CORRECTIVE MEASURES STUDY WORK PLAN RATIONALE FOR NO FURTHER ACTION
SOLID WASTE MANAGEMENT UNIT 47 (SWMU 47) ZONE C WITH TRANSMITTAL CNC
CHARLESTON SC
4/2/2001
NAVFAC SOUTHERN

CORRECTIVE MEASURES STUDY WORK PLAN

Rationale for No Further Action **Solid Waste Management Unit 47, Zone C**

Re: Corrective Measures Study (CMS) Work Plan - Rationale for No Further Action for
SWMU 47, at the Charleston Naval Complex (CNC), Revision 1

Figure 3-1
Soil Sample Locations
SWMU 47, Zone C
Charleston Naval Complex

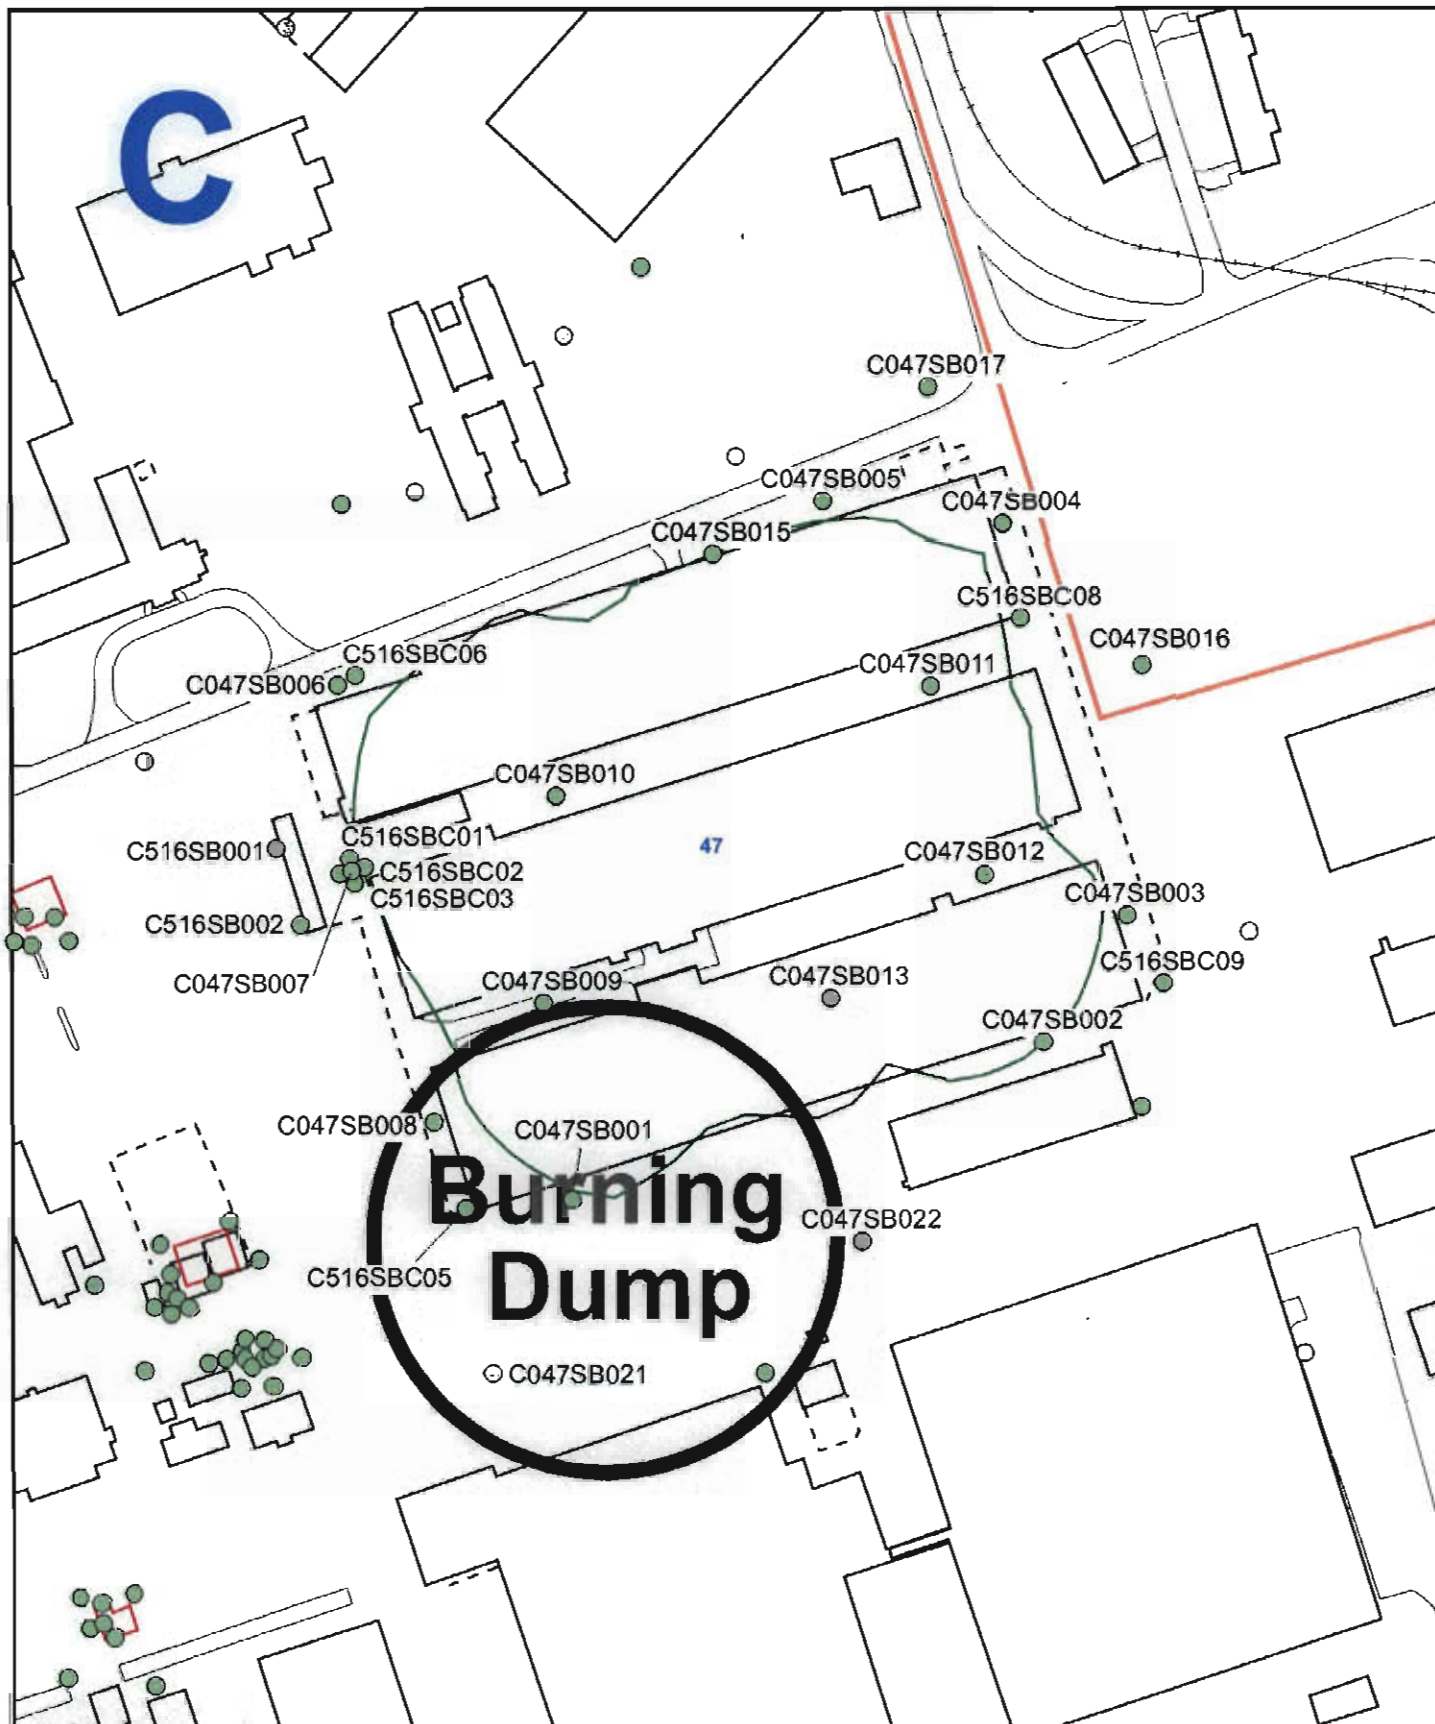
2. Section 3.1.2 Subsurface Soil, Lines 1-3: The text refers to Fig 2.2 as illustrating the locations of soil samples analyzed as part of "this IM WP". The Fig 2.2 represents base conditions in 1924 and 1926 and the text seems to be referencing the IM WP for AOC 516. Please clarify and amend the statement as intended.

Response: The first paragraph of Section 3.1.2 should have referred to figure 3-1 and "this CMS WP". Below is the revised paragraph that will be included in the revised report.

"Subsurface soil samples were collected as part of the RFI at each of the soil boring locations. Figure 3-1 illustrates the locations of the soil samples analyzed as part of this CMS WP.

Figure 3-2
Groundwater Sample Locations
SWMU 47, Zone C
Charleston Naval Complex

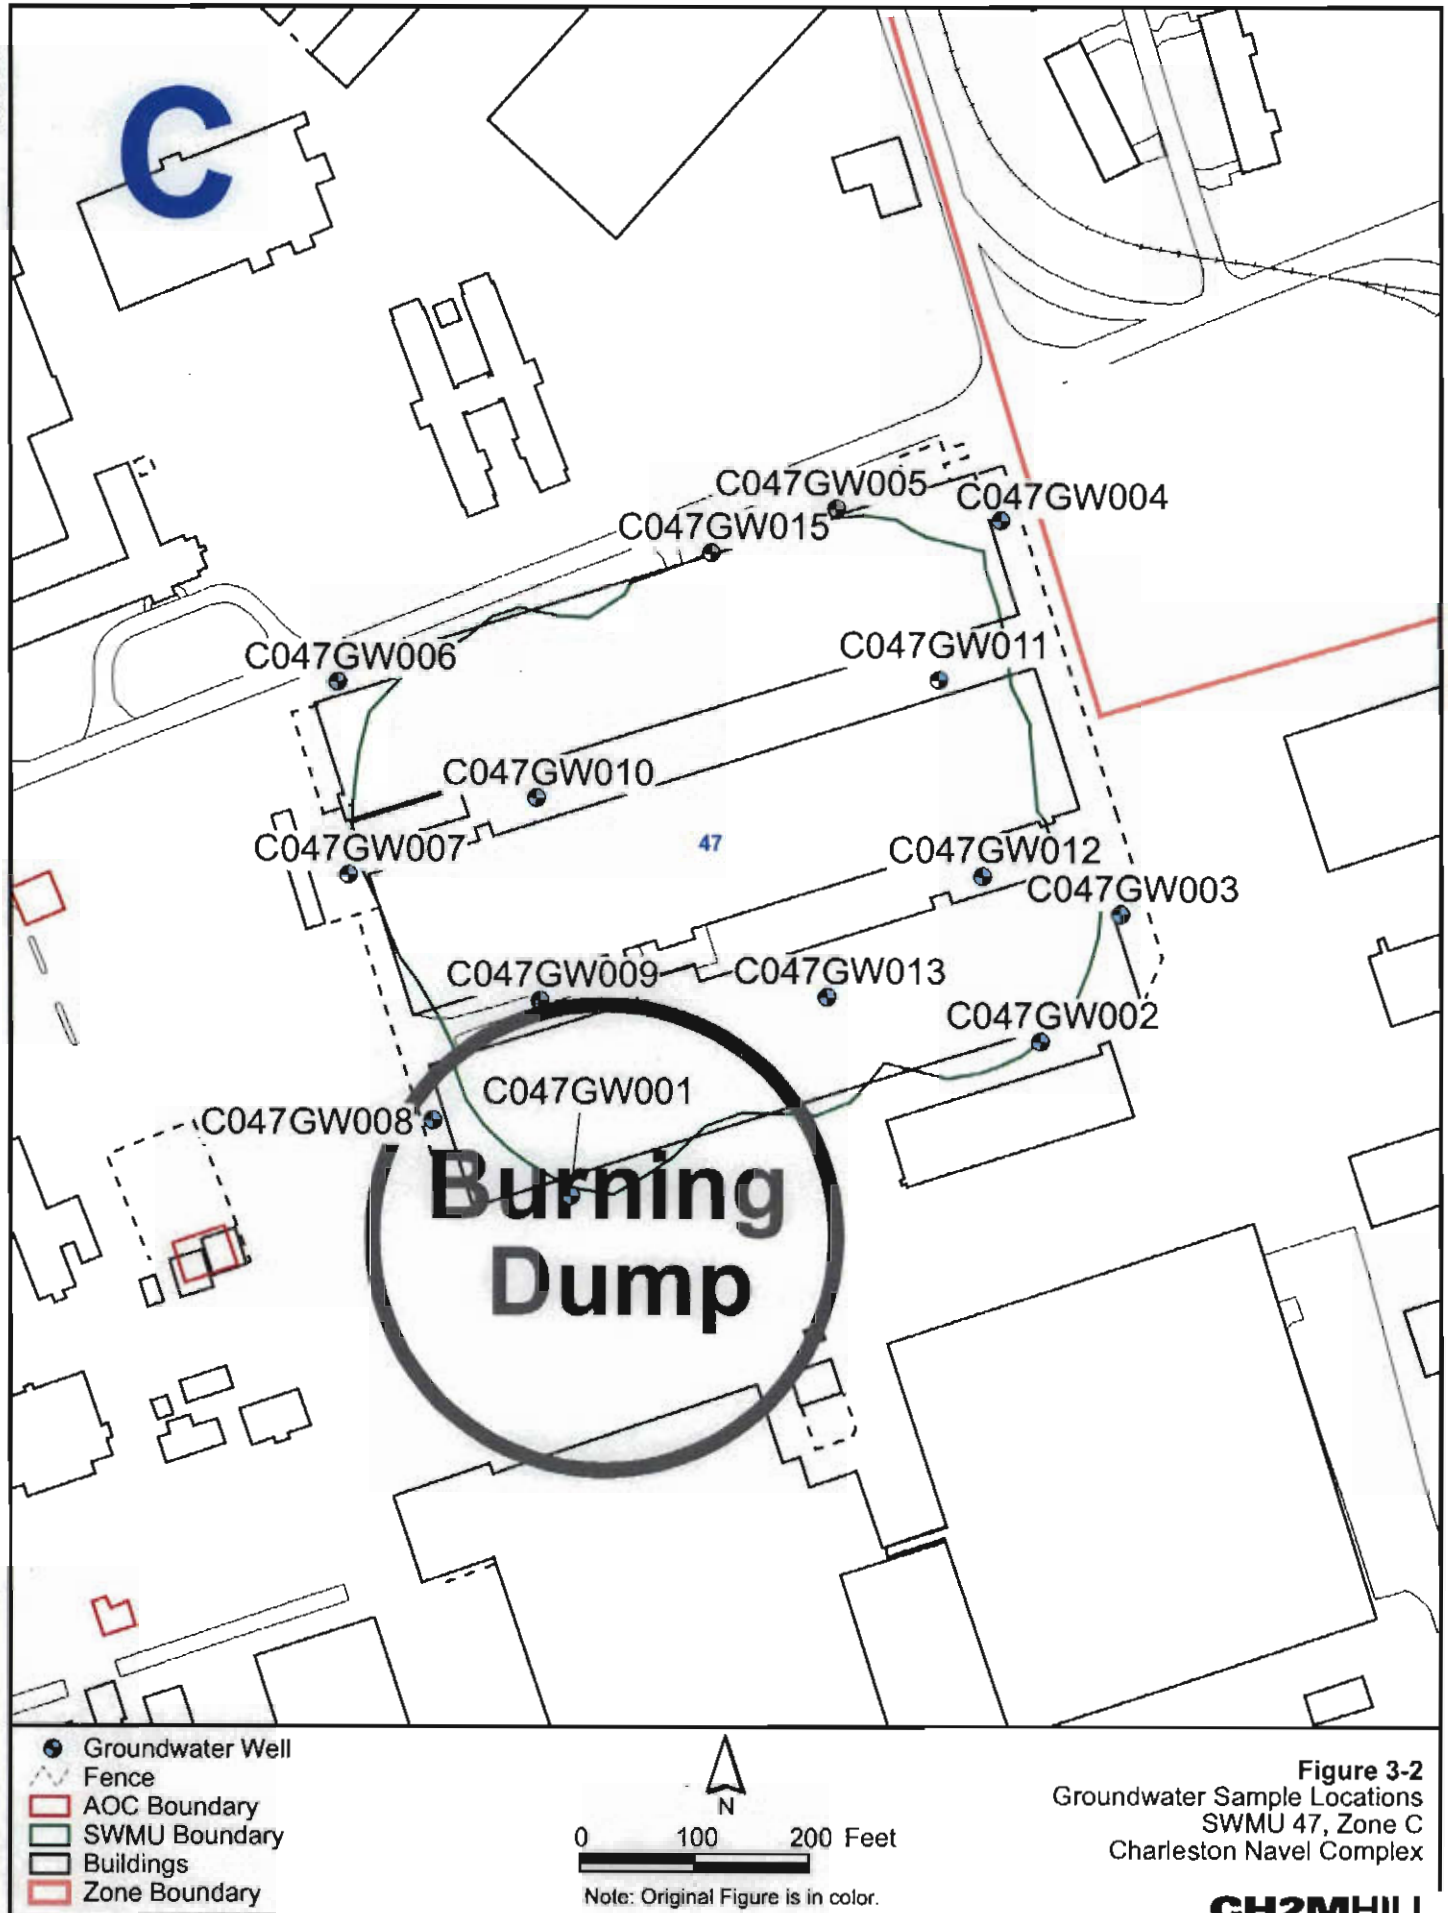
Section 3.1.3 Groundwater, (page 3-5), Line 30+: the text referenced location C047GW011. This location is not shown on figure 3-2 provided in the section. Please include.

Monitor well C047GW011 was inadvertently omitted from Figure 3-2. It will be added to the figure.
